To: Derek Robinson, HPNS BRAC Environmental Coordinator Department of the Navy BRAC Program Management Office West 33000 Nixie Way, Bldg. 50, 2nd Deck San Diego CA 92147 derek.j.robinson1@navy.mil

### 1. The Navy seems to completely disregard the need for retesting.

# 3. The Navy has claimed that samples reading hot for Radium-226 were biased high, when in fact this is not the case.

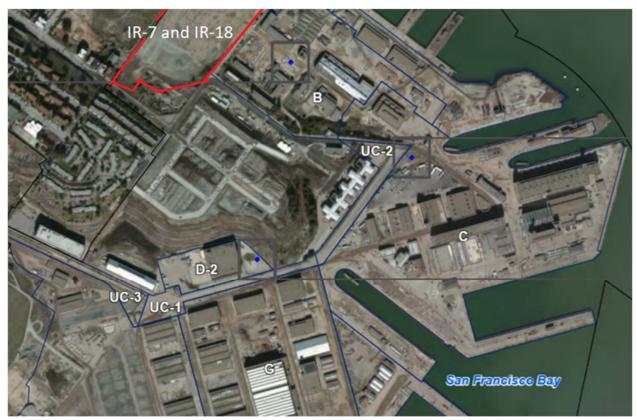
The Navy now astonishingly claims that the measurements and measurements techniques it approved for years for Radium-226 were in fact biased high and that it knew this for years and nonetheless allowed tens of millions of dollars to be spent cleaning up soil that didn't need to be cleaned up. It bases this extraordinary claim on the assertion that the onsite laboratory couldn't discriminate between the Radium-226 gamma peak and the nearby Uranium-235 peak, and therefore the Radium value may have been high. It says this based on the assertion that U-235 is not a radionuclide of concern and therefore should be ignored. However, there were large amounts of U-235 used at Hunters Point, from unfissioned U-235 in weapons fallout and ship contamination to licensed uses for NRDL. Indeed, the ROD identifies U-235 as a radionuclide of concern (see table above). It matters little to public health whether the radioactivity in the soil sample is pure radium-226 or radium-226 plus uranium-235; they are dangerous alone or in combination. Furthermore, the remediation goal for U-235 is an order of

magnitude lower (i.e. more protective) than that for radium-226, so if part of the sample is uranium-235 rather than pure radium-226, that would make it more dangerous, not less. So to try to reduce the radium values by this spurious claim and declare 80% of past cleanup to have been unnecessary is a sign of the Navy behaving in precisely the fashion that got Tetra Tech into trouble.
